**SUNDRY NOTICES AND REPORTS ON WELLS**  
*Do not use this form for proposals to drill or to re-enter an abandoned well. Use Form 3160-3 (APD) for such proposals.*

8. Well Name and No.  
Lybrook I02-2308 02H

Encana Oil & Gas (USA) Inc. is requesting authorization to install gas lift at the Lybrook I02-2308 02H well. Attached is a schematic of the pad with gas lift and the gas allocation procedure.

### **CONDITIONS OF APPROVAL FOR GAS LIFT, BUY BACK METER AND CDP INSTALLATION:**

# Lybrook I02-2308 01H & 02H

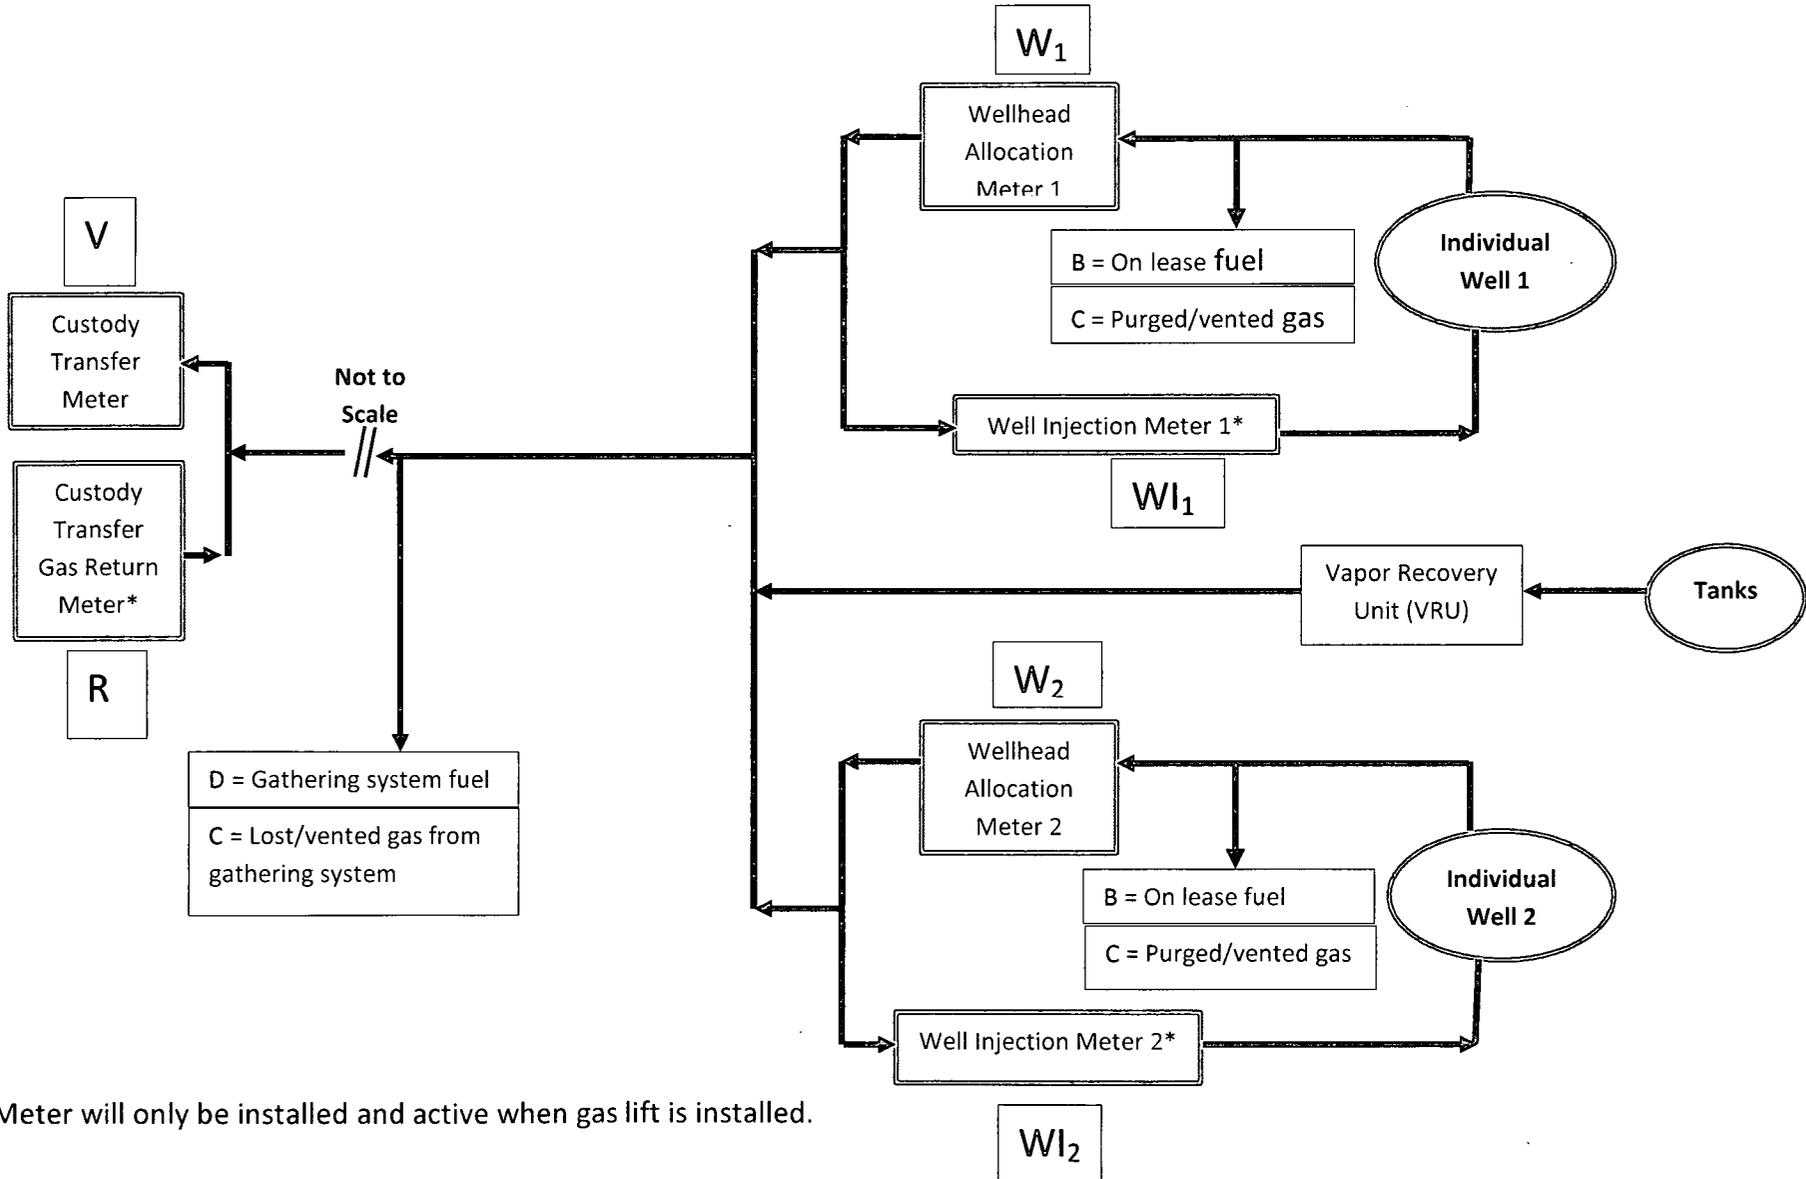
- The buy-back meter isolation valve, either up or down stream of the buy-back meter must be effectively sealed in the closed position to prevent produced gas from potentially by-passing the measurement and sales meter. In lieu of the seal requirement at least two check valves can be installed immediately upstream and downstream of the buy-back meter to prevent produced gas from potentially by-passing the measurement and sales meter.

Contact this office so a BLM witness may verify installation of either the seal or check valves.

**Clearly identify both the sales and by-back meters.**
